From: [REDACTED]
Sent: Monday, March 25, 2024 2:03 PM
To: Sullivan Archer <Sullivan.Archer@hinckley-bosworth.gov.uk>
Subject: Email response to: 23/01204/REM: Land south of Sketchley Grange, Sketchley Lane, Burbage

General Arrangement Planning drawing number 23053 – 051 revision -; and
Swept Path Analysis Planning drawing number 23053 – 051 revision A

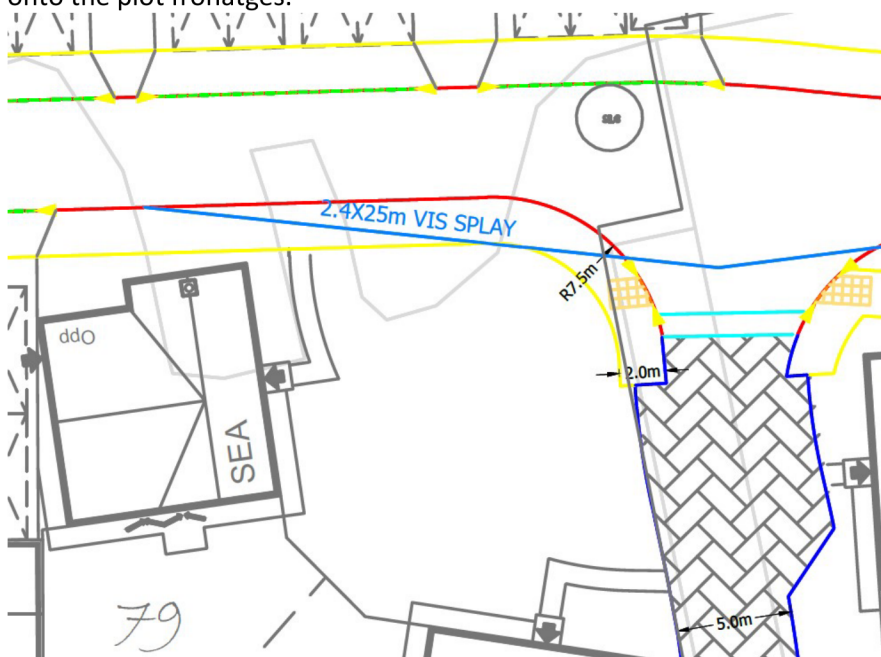
The LHA welcome the inclusion of visibility splays at junctions and bends on the submitted General Arrangement Planning drawing number 23053 – 051 revision -. However, the LHA highlight that visibility splays need to be provided within the designated highway and not encroach onto the curtilage of the proposed dwellings.

Therefore, the visibility splay shown fronting plots 79 & 80 should be revised accordingly as it currently encroaches onto the plot frontages.

In addition, the LHA highlight that the forward visibility for the bend in the spine road fronting Plot 90, would be obscured by the proposed dwelling in this location. This needs to be addressed by the applicants. The LHA highlight that the turning head in this location deemed to be excessive as per our previous observations dated 30 January 2024. This may result in a reduced visibility splay being required.

The LHA highlight that the submitted tracking drawing is extremely tight and shows a conflict point then manoeuvring from the spine road into the shared surface serving plots 15-33. Which could result in an increased risk of kerb strikes or overrunning of the tactile pedestrian crossing resulting in damage and an increased risk of in loss of control type collisions.

In addition, the LHA highlight that the submitted tracking drawing shows the need for the refuse vehicle to mount a section of the footway fronting plots 46 & 47. This is not considered acceptable and would present a severe highway safety concern.

Given the above, the applicants are advised to review the layout to ensure that the minimum required visibility splays are provided within the designated highway.

Access to private drive plots 5 to 12

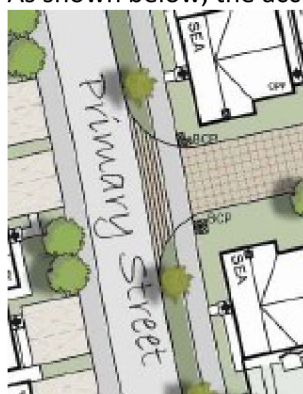
As shown below, the access to this private drive is detailed as a radii access.

This is not considered acceptable for the number of dwellings served and therefore needs amending to detail a dropped kerb vehicle access point.
